Planning Application
by Puy du Fou UK
Land North-West of Bicester

TRANSPORT ASSESSMENT ADDENDUM

Document reference: Transport Assessment Addendum

May 2026

PRoW measures (North Plan)

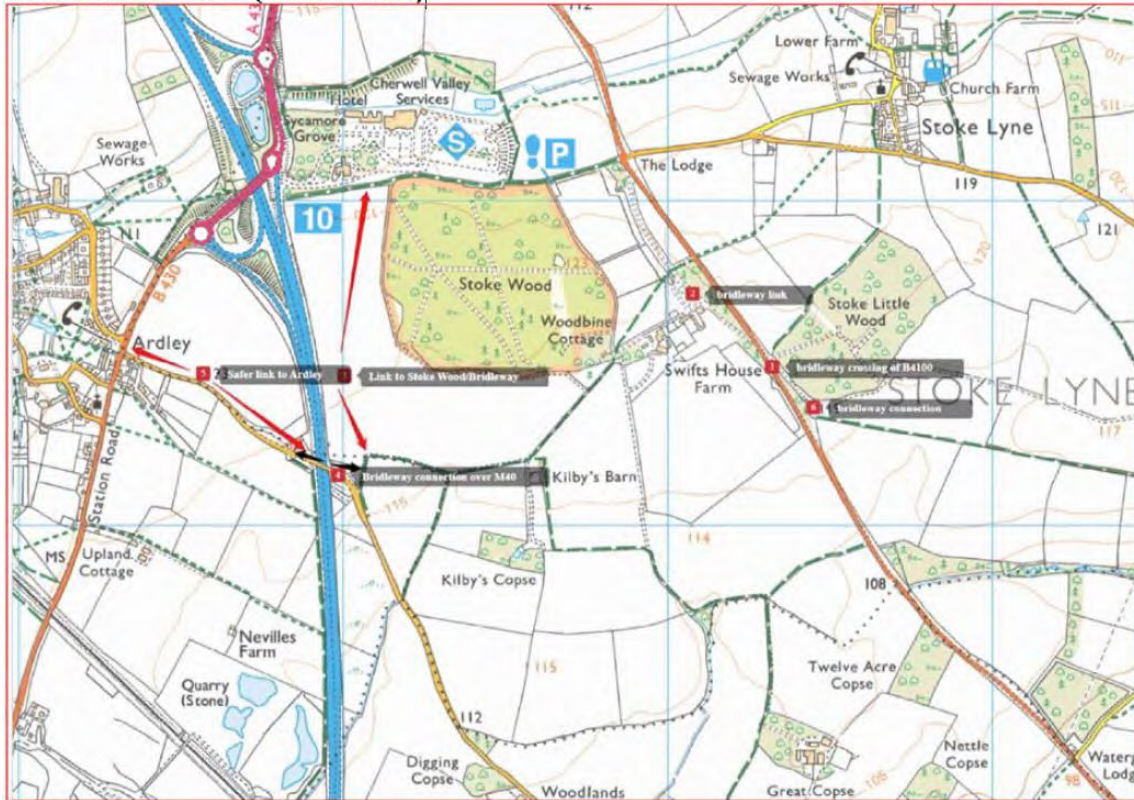
There follows a simple north and south annotated PRow measures plan and estimated costs table. It will be important to commit to these and bring them into use early on in the development's journey.

Summary: Parallel crossing too close to the roundabout give way line.

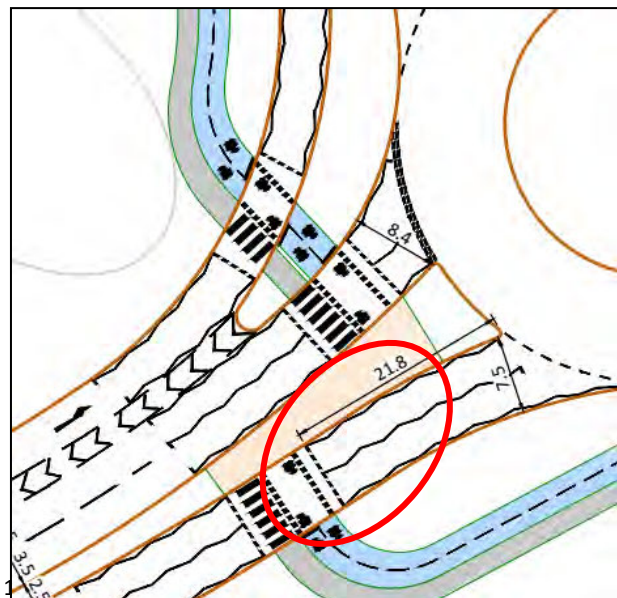
The proposed Parallel crossing will only be a short distance prior to the roundabout give way line. As such, it may not be possible for all vehicles to wait

at the give way line without obstructing the crossing. This may increase the risk of collisions with NMUs using the crossing as dwelling vehicles move off when a suitable gap becomes available to enter the junction.

Location: M – Equestrian crossing NW of the proposed NW roundabout.

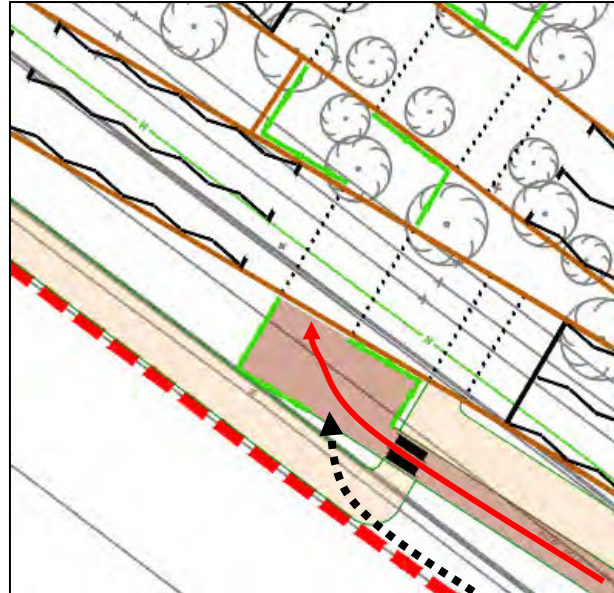
Summary: Crossing layout does not appear to allow the horse to turn so the rider can view approaching traffic.

Figure 1: Daily visitors Year 10 and scenario 10b 85th percentile

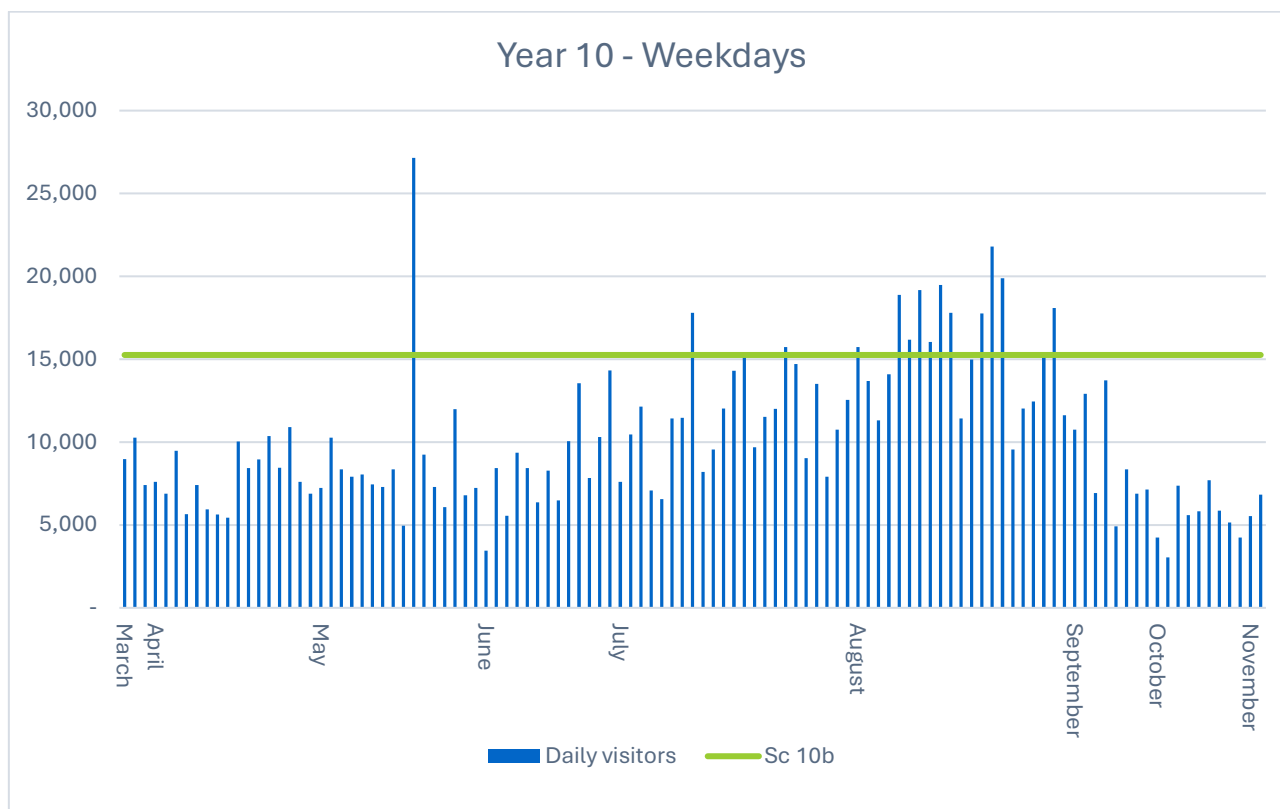
However, Figure 5.1 requires clarification as, during preapplication discussions, we were told there would be only 5 days in a year where attendance would be above the 85th percentile. Fig 5.1 appears to show around 40 days.

20. **Figure 1** confirms that the selected 85th percentile level provides a robust and efficient basis for infrastructure and traffic design, capturing typical high-demand conditions without over-representing exceptional peak events. **Figure 1** demonstrates 15 instances throughout the year that the 85th percentile is exceeded for the 10b scenario.
